Solution

Title (customer effect)	Automated Manual Transmission (AMT) Power Take-Off (PTO) Solenoid Bracket Modification For Dual PTO Solenoids
-------------------------	---

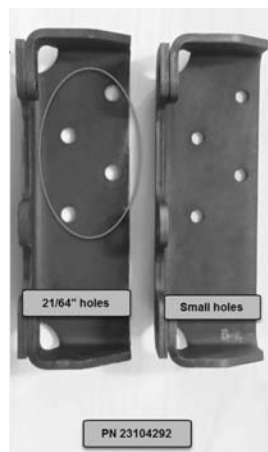
Cause	On 14 August 2017 a new PTO solenoid for the AMT has been released to address issues with breakage when mounting dual solenoids. The dual PTO solenoid set up cannot be mounted on this new bracket without modifications. This is being corrected. Single PTO mounting is not affected.
-------	--

Solution	The four mounting holes in the bracket are too far apart to allow two solenoids to be bolted to the bracket properly. Single PTO solenoid installations are ok. If a unit that is built with bracket Part Number 23104292 and a single PTO solenoid setup is modified to be a dual PTO setup, the mounting holes in the bracket must be drilled out to allow the bolts to line up.
----------	--

Drill the 4 mounting holes out to 21/64" to allow for bolt alignment. See the image below.

The new bracket, Part Number 23220187, will have the hole locations corrected and will not require modification to mount dual PTO solenoids.
